Reviewer comments appear in **black** and author responses in **blue**.

## Reviewer 1

The paper addresses the effect of a large wind farm cluster on the frequency and magnitude of sea spray freezing events. The conclusion is that the effect of even a very large cluster, and in an environment prone to these events, is minimal. The paper thus ends the scientific debate on this topic.

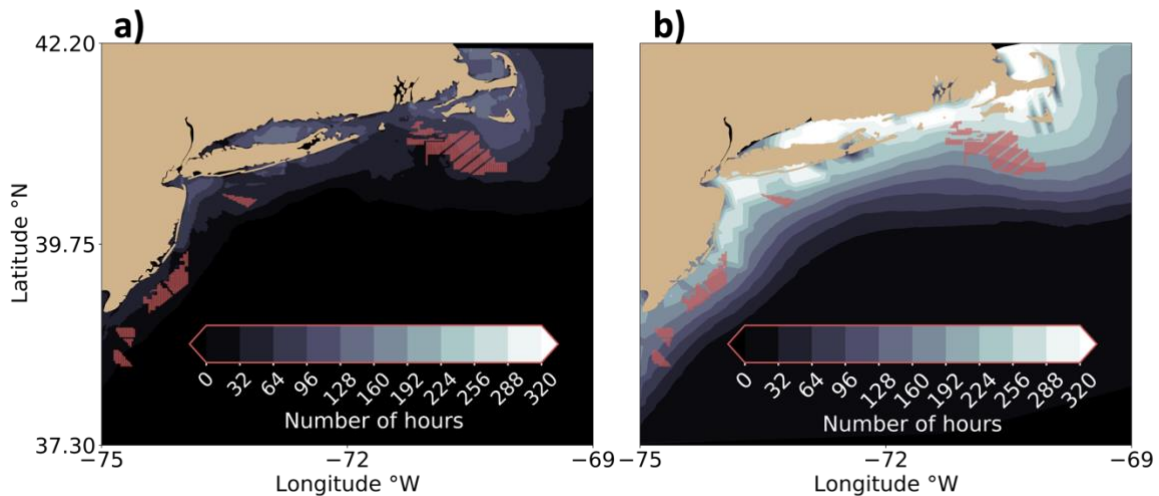
229-230, Figure 2 caption. Please normalize the color scales on the two plots so that they can be compared. For example, show the number of hours per season. We have normalized the color bars between the figures for comparison. We now show the mean number of hours per season in panel (b) as requested.

Figure 3. The maximum number of FSS hours over the OCS (a) annually and (b) seasonally in NOW-23. The zoomed orange cutout shows the seasonal variation over the 2019–2020 winter.

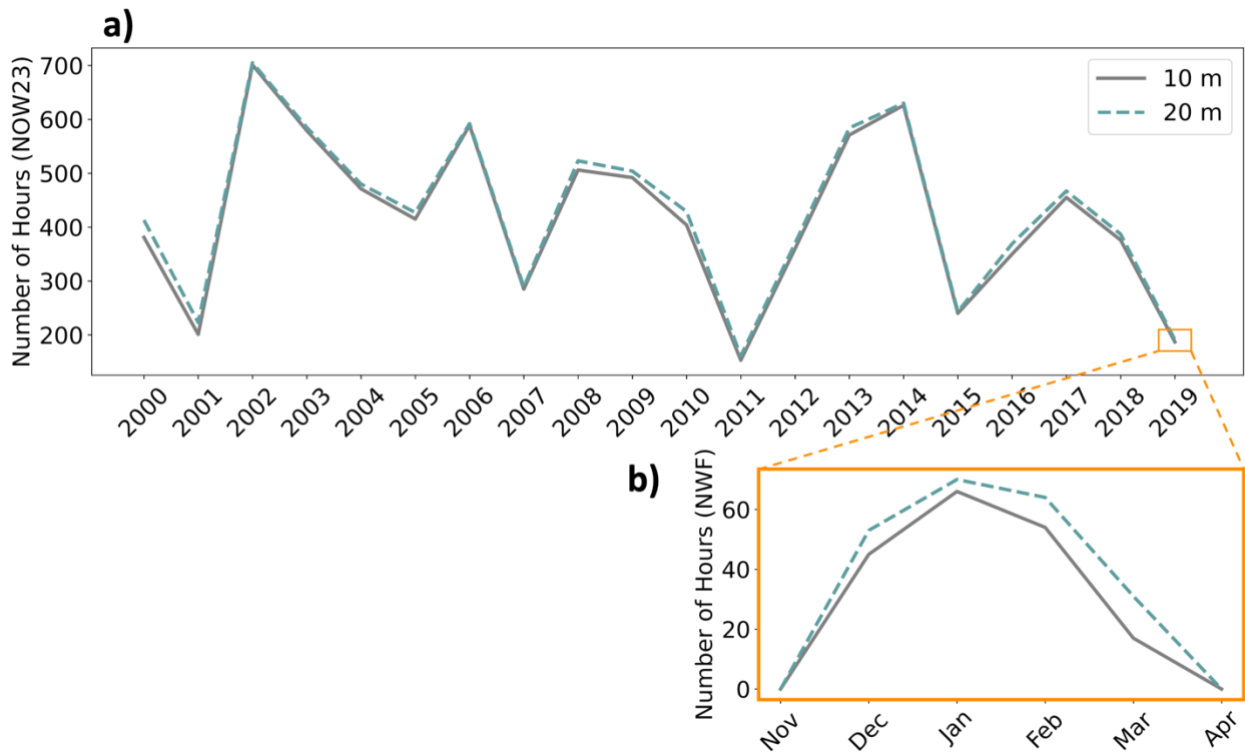
245 Figure 3. It is not immediately clear where the zoom fits. Please consider redrawing.

We have redrawn the figure to make it clearer where the zoom fits and have also added a more explanative caption:
